**Grimes Planning and Zoning Commission
March 4, 2025 @ 5:30 PM
Grimes Community Complex, 410 SE Main Street**

RE: Merkle Retirement Planning Site Plan Amendment

PLAT & CONSTRUCTION PLANS
FOR
MERKLE FINANCIAL BUILDING ADDITION
1860 SE PRINCETON DRIVE
CITY OF GRIMES, POLK COUNTY, IOWA

RE: TMJ Roofing Building Addition Site Plan Amendment

1 EAST ELEVATION
SCALE: 3/16" = 1'-0"

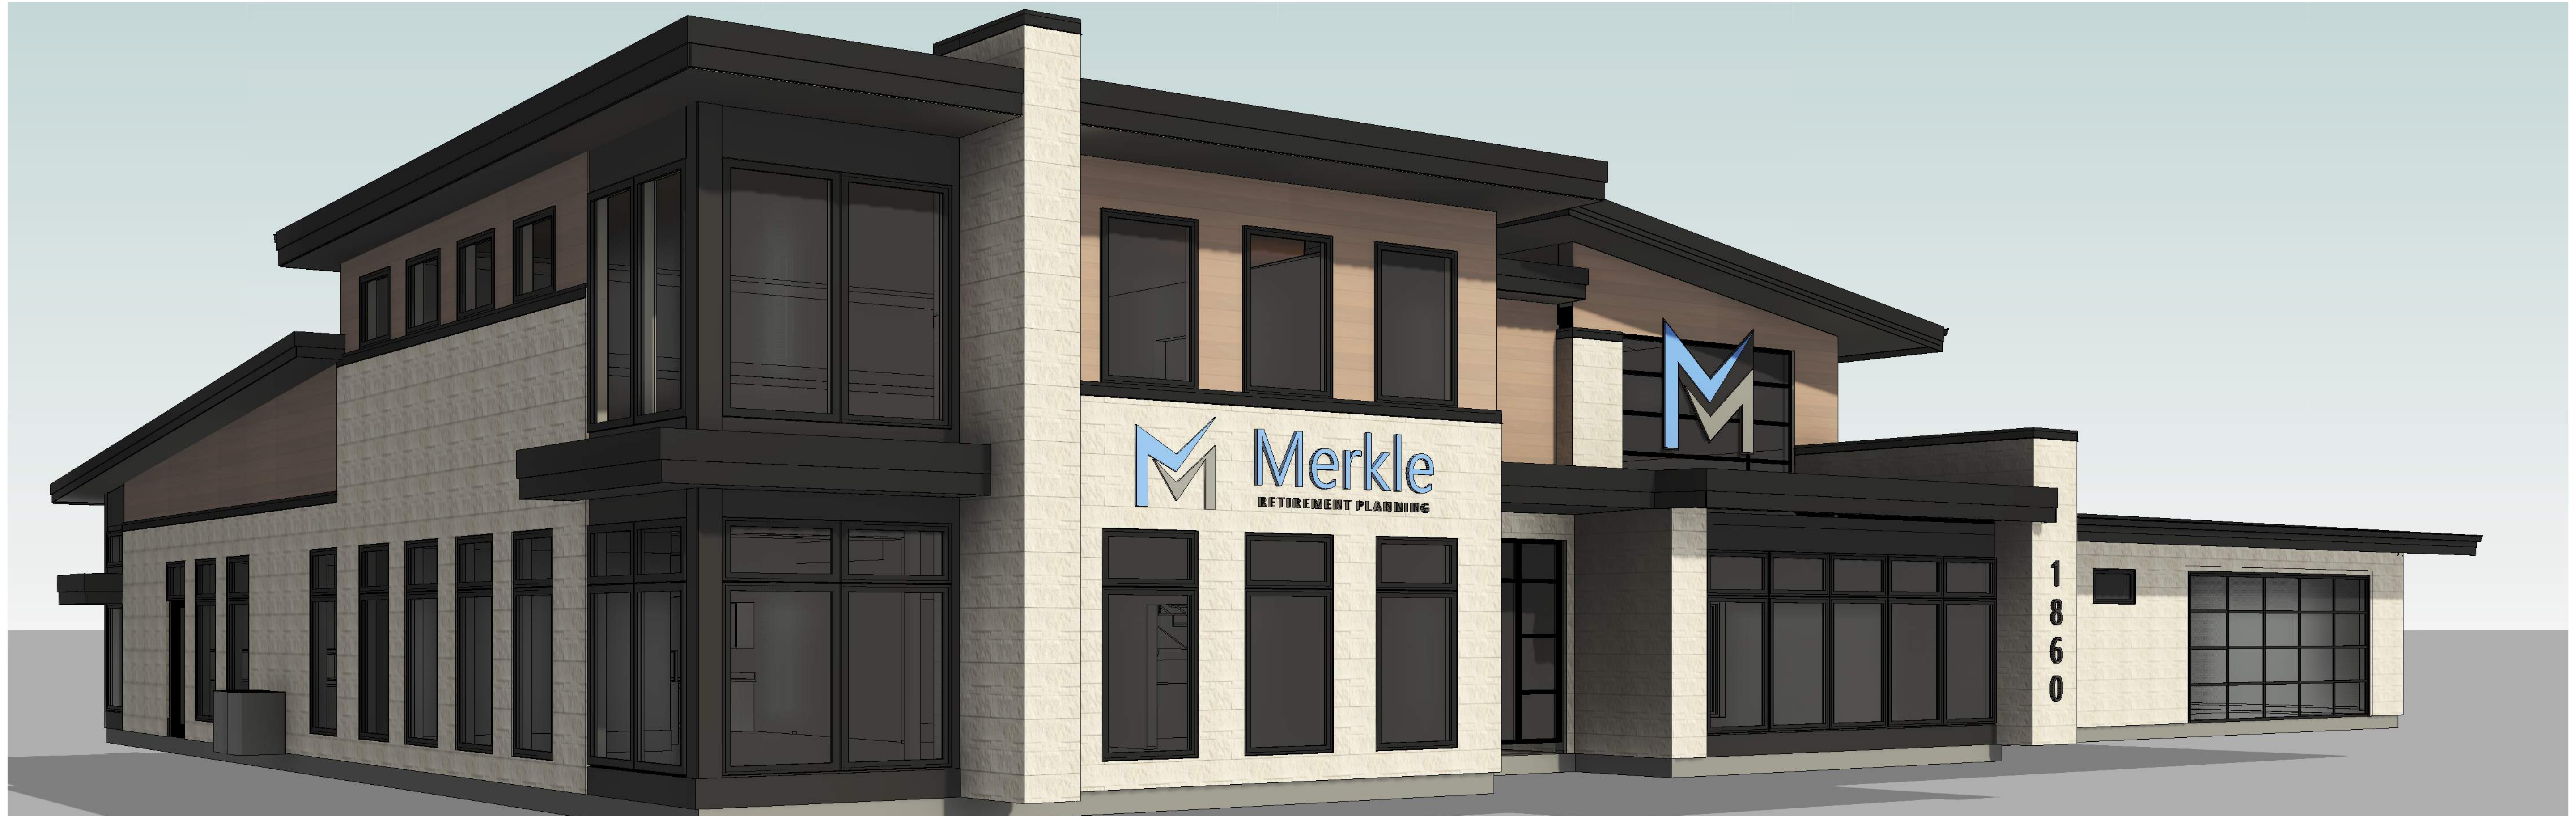
1. ~~Provide material percentages for the building addition to demonstrate that the addition meets the 75% masonry requirement for Zone 1. The entire east elevation meets the 75% requirement so there are no issues.~~

2. ~~Provide calculations to demonstrate that the east elevation meets the minimum 20% glazing requirement.~~
3. ~~Label all materials on the elevations and provide material descriptions and colors.~~

EAST ELEVATION GLAZING SF	
GLAZING SF	949 SF
TOTAL SF	2038 SF
GLAZING %	47%

SITE & GRADING PLAN

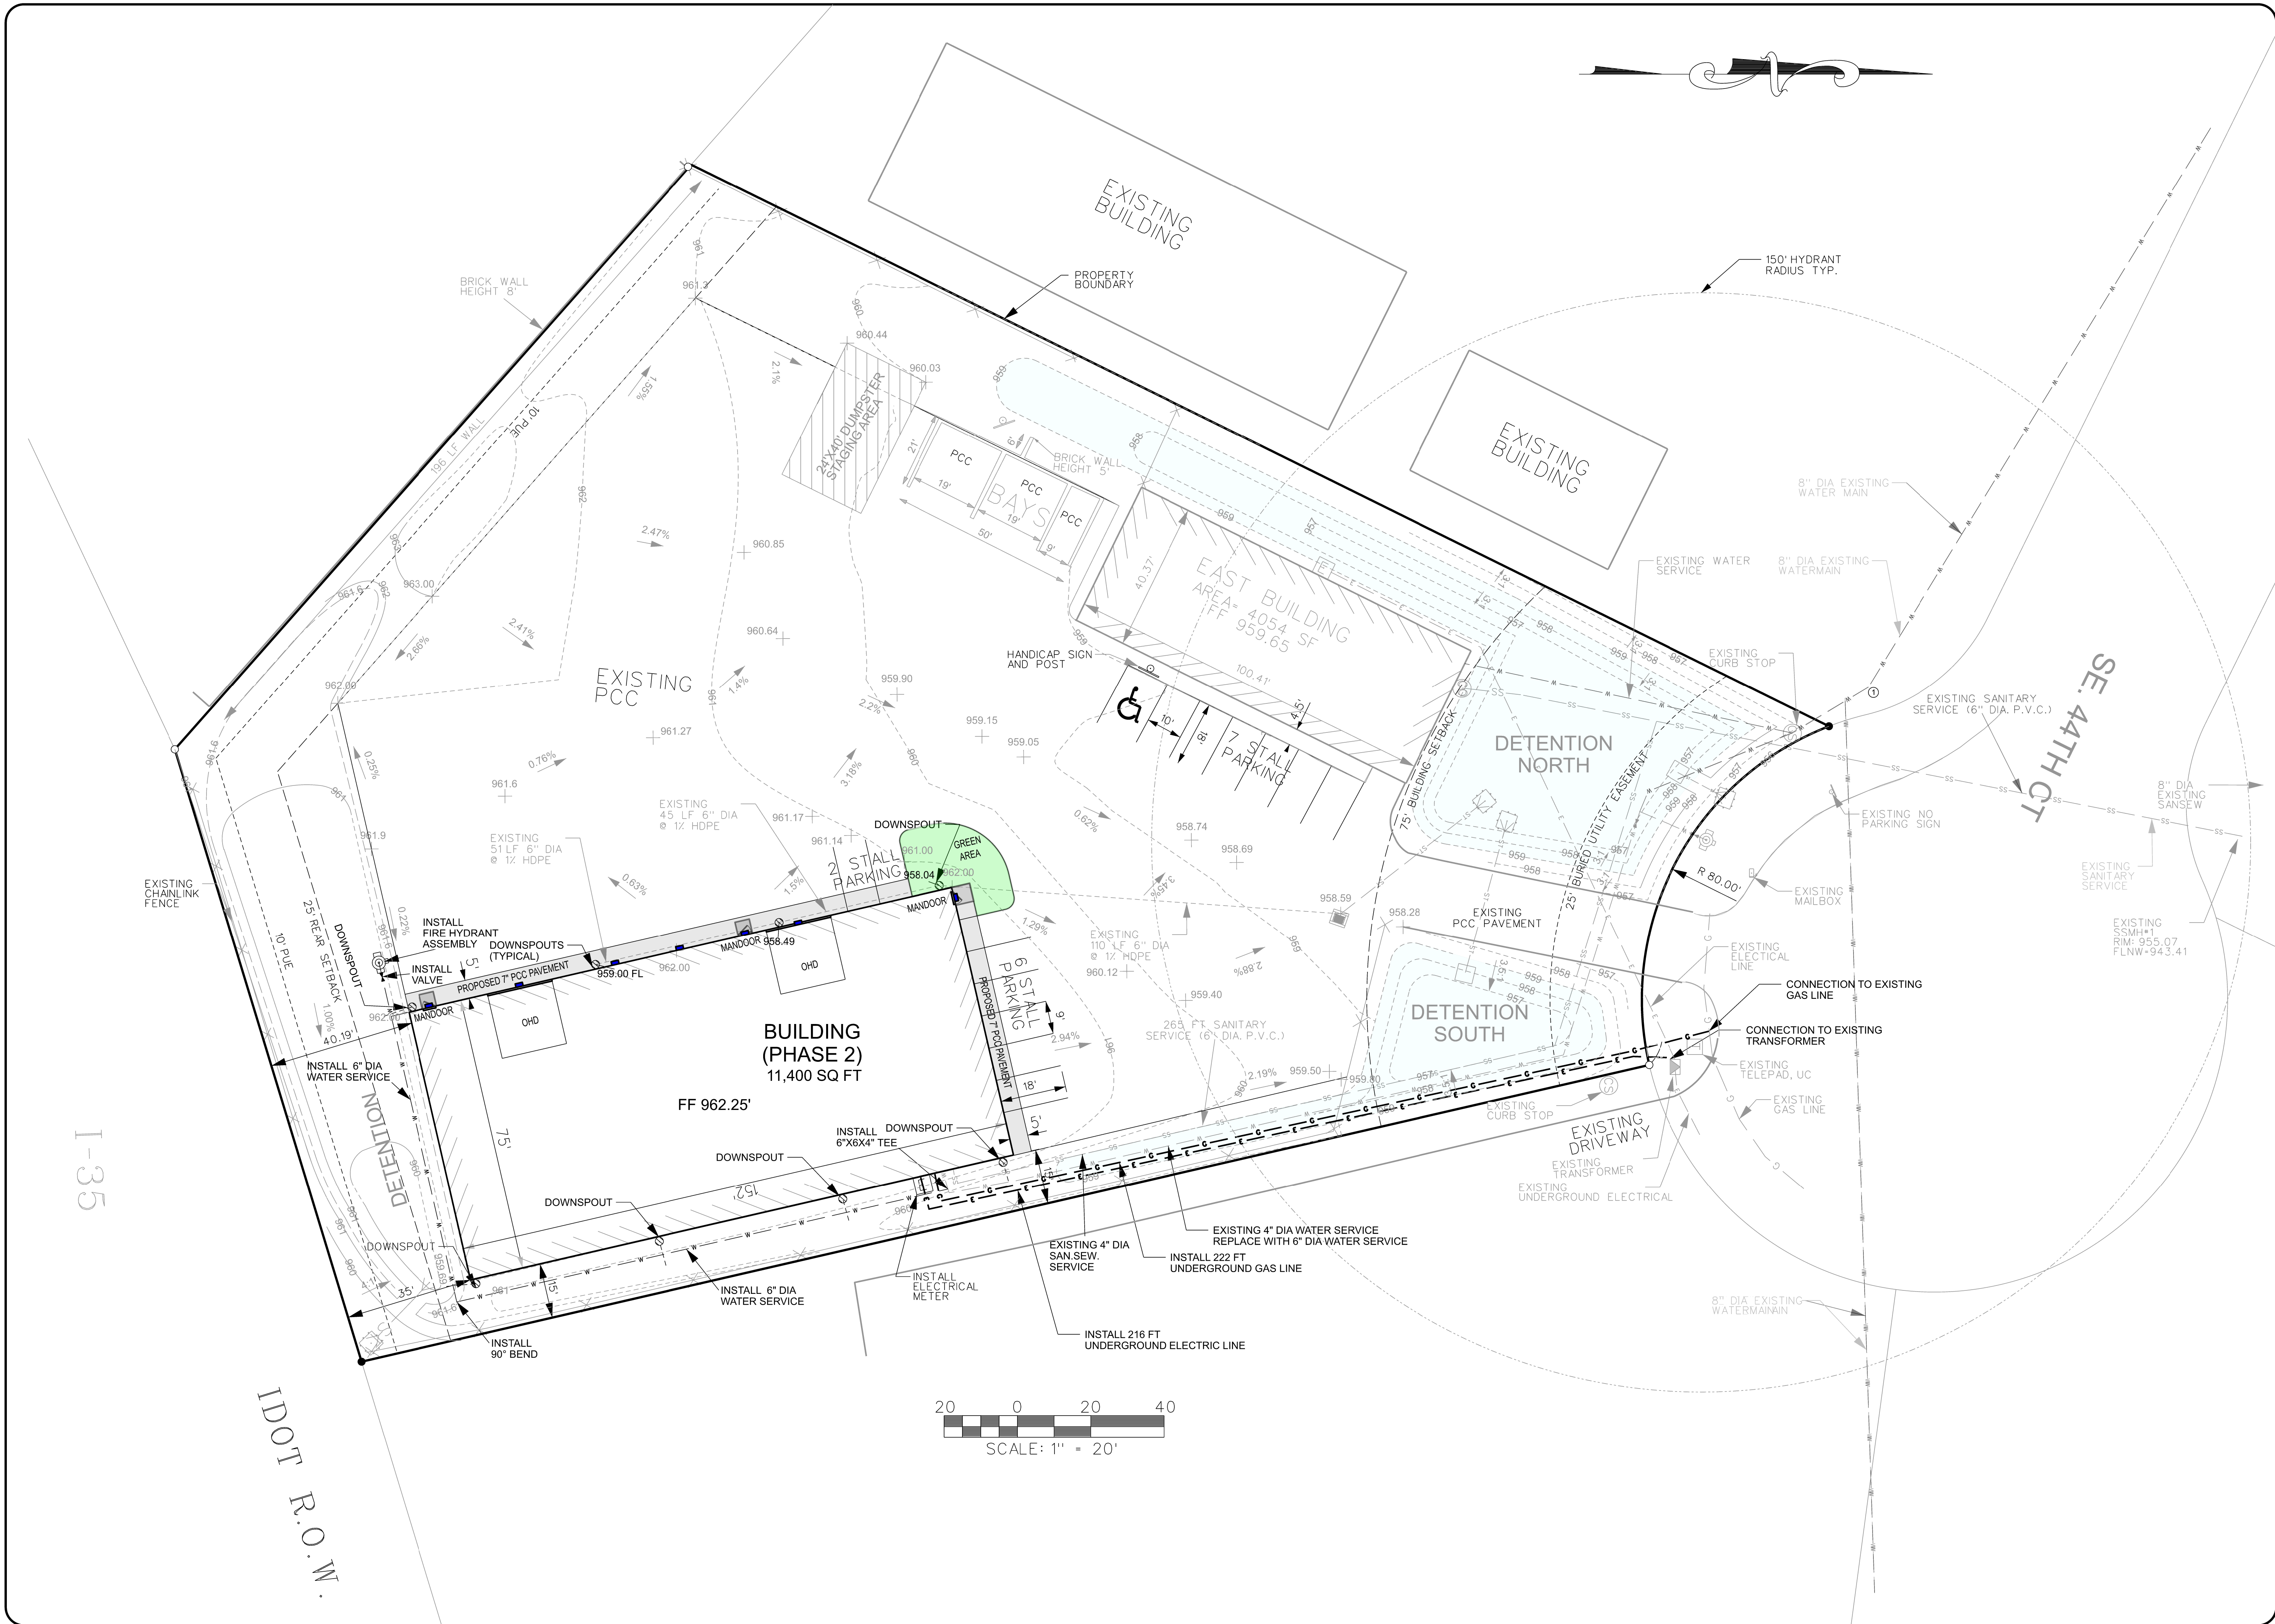
- 1. ~~Provide a site plan for the Phase 2 improvements (building, paving, and storm, etc.). Our thought is that the Phase 1 site plan could be altered to show the Phase 2 improvements to be constructed and show the Phase 1 improvements grayed out as existing.~~

- 2. ~~Update the building footprint on the site plan. Update to 152' to match the building design.~~
- 3. ~~Ensure the downspout locations and downspout drain connections are coordinated with the building design. Staff would recommend connecting the downspouts on the west side of the building to storm sewer so water does not freeze in front of the man doors and overhead doors.~~

- 4. ~~Label frost protected stoops at personnel doors. Ensure door locations do not conflict with parking spaces. Provide required clearance from parking.~~

- 5. ~~Provide water and sanitary services to the building. Restrooms are required in the building. Please label on the site plan. Show as new, not existing. The water and sanitary service are shown as existing. Please label the size of both service lines.~~

- 6. ~~Staff is verifying with the fire department any hydrant coverage requirements for the new building. Any comments will be provided asap. A hydrant will be required to be extended into the site to provide hydrant coverage for the new building. Please show the location on the site plan. Please label the length of the new water line.~~

proposed for the building? Based on the square footage and type V-B construction, a fire suppression system is required. Please provide the fire service line and FDC location on the site plan. FDCs are required to be within 100' of a hydrant. Below is an example detail for the fire and domestic water service split with curb stop. **Please label the location of the FDC.**

8. ~~Label knox box location on the building.~~
9. Update Note 1 on Sheet C2 to "Tap **6**" diameter service", instead of 4"
10. Update the front entrance man door and stoop to the west side of the building to match the building.
11. Adjust parking and landscape island as needed to accommodate relocated front door location.
12. Provide minimum 5' walkway between the front entrance and the parking stalls on the west side of the building. Relocate downspout away from front entrance.

13. If the pavement in blue remains, provide 5' walkway to the parking lot.

GREINER BUILDINGS INC.
120 EAST MAIN ST. WASHINGTON, IA

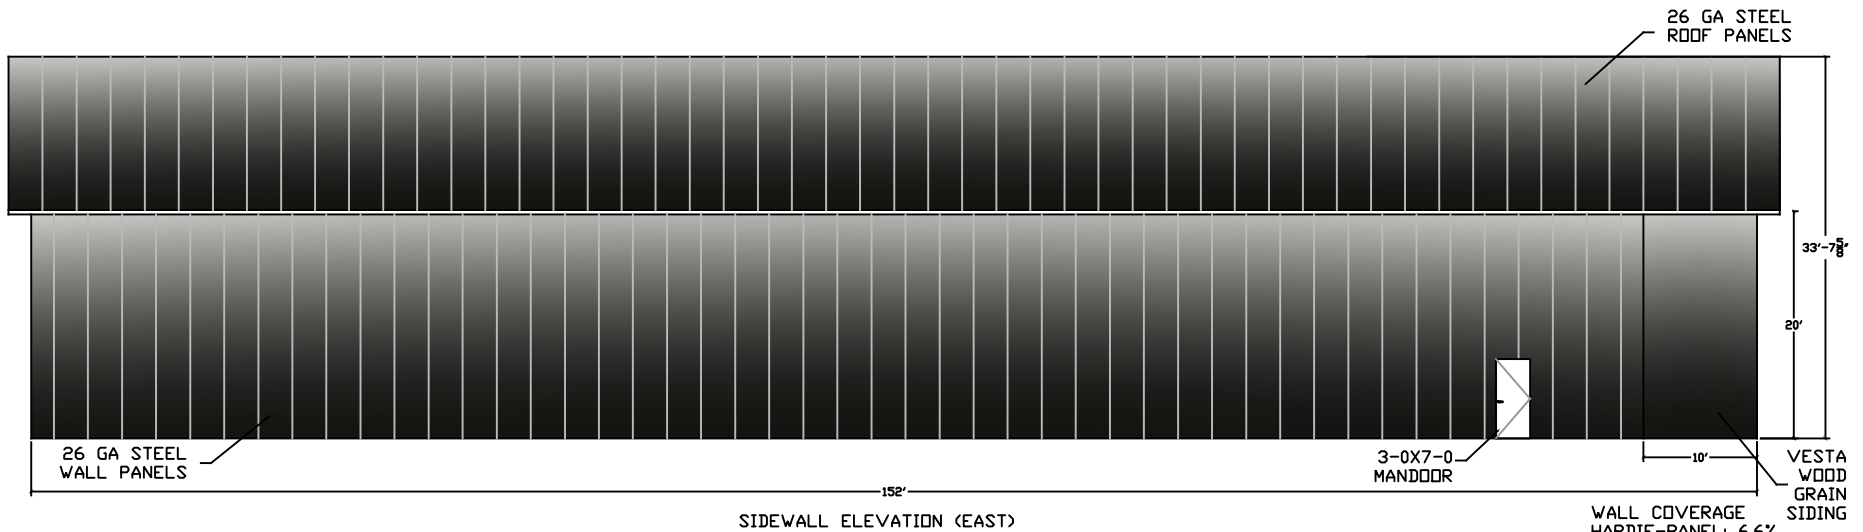
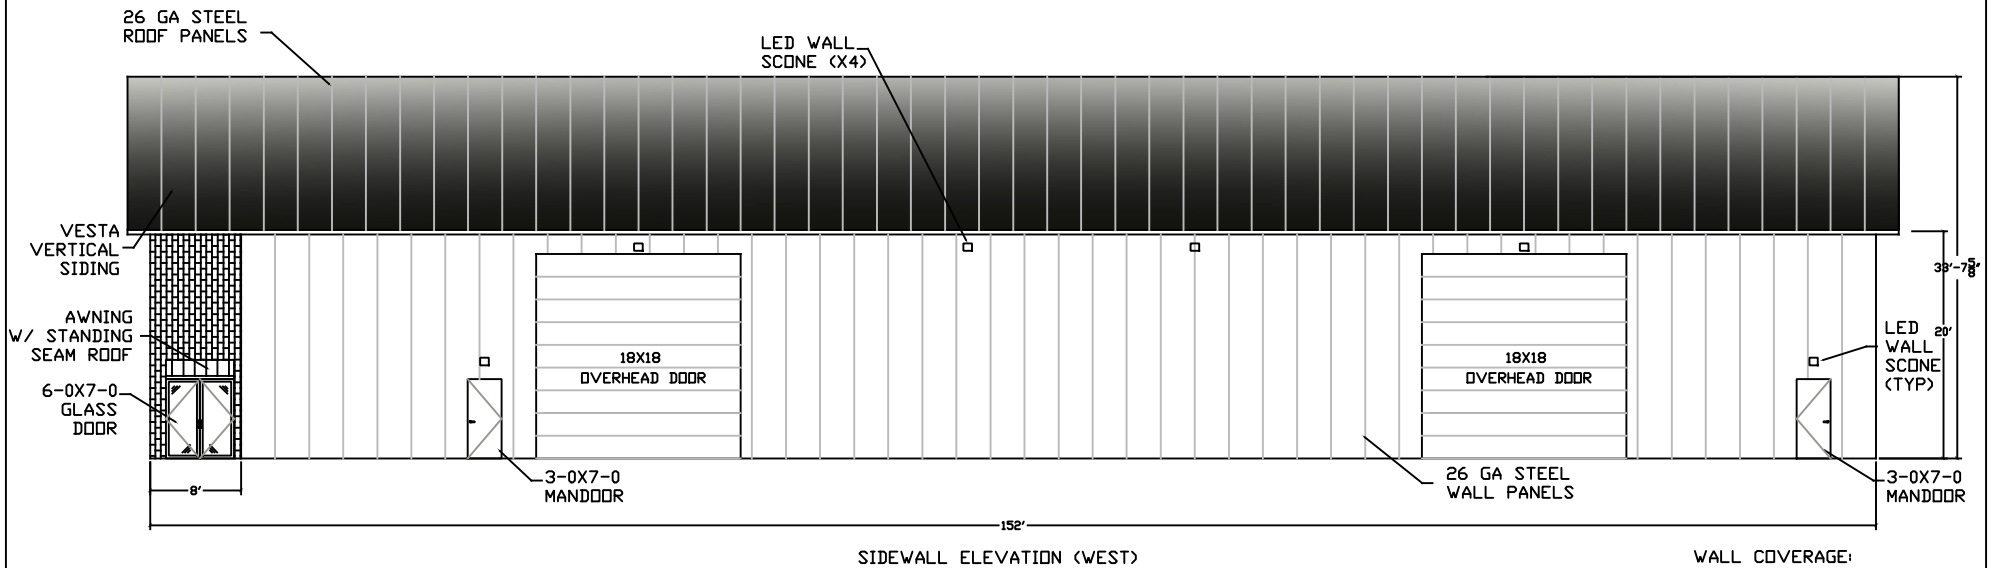
1. Please provide color drawing of the proposed building with elevations of all four sides of the building.
2. Label the cardinal direction of each building elevation.

3. Provide material descriptions and specific colors of all exterior building materials. Label color of the metal panel.
4. Provide building material percentages on all four sides of the building. A minimum of 75% of the front building face and 10' along the adjacent sides, excluding glass, are required to consist of primary material. Primary material is considered earthtone-colored brick, architectural concrete panels, textured concrete block, marble or stone panels.

5. For the two sides adjacent to the front building face, a minimum of 25% of the first 30' is required to consist of primary material. Demonstrate that the building meets this requirement by providing a calculation. It appears the design does meet but please provide the calculation to confirm.

7. Provide and label 5 design elements demonstrated on the building. See 12-11-1.24.A.2.b.ii. for the list of design elements. Please label and/or list the 5 elements provided on the elevation drawings per Section 12-11-1.24.A.2.b.ii. Five elements must be demonstrated on the building. It appears additional elements are required on

8. ~~A minimum of 20% glass/glaze is required along the front facing the public street.~~
9. ~~Are lights proposed on the building faces? Please label locations and provide the lighting specs for the fixtures. Lighting is required to be shaded/hooded to direct light down and hide light sources. Is there an option to add a shade/hood to the proposed lights? If so, would you please provide the spec for the shade/hood? Otherwise, please provide the spec for a different light fixture with a shade/hood. Something similar to the image below.~~

10. ~~Staff would recommend providing some of the wood-look material on the north elevation similar to the first proposal to tie in with the existing building. If the wood-look material is added, please update the material percentages accordingly. Windows and doors do not count toward the material percentage. For example, the current design would be 100% Hardie panel without counting the windows. The rendering provided shows the wood-look material but it is not shown on the building elevation. Is the wood-look material planned to be provided on the building? If so, please update the elevation drawings to include the wood-look material.~~
11. ~~Please provide the updated hand drawn building elevations with details noted in my 2-25-25 email.~~

WALL COVERAGE
HARDIE-PANEL: 6.6%
26 GA STEEL: 93.4%
3040 SQ. FT.

WALL COVERAGE:
VESTA VERTICAL: 5.3%
DOORS: 22.7%
26 GA STEEL: 70.7%
3040 SQ. FT.
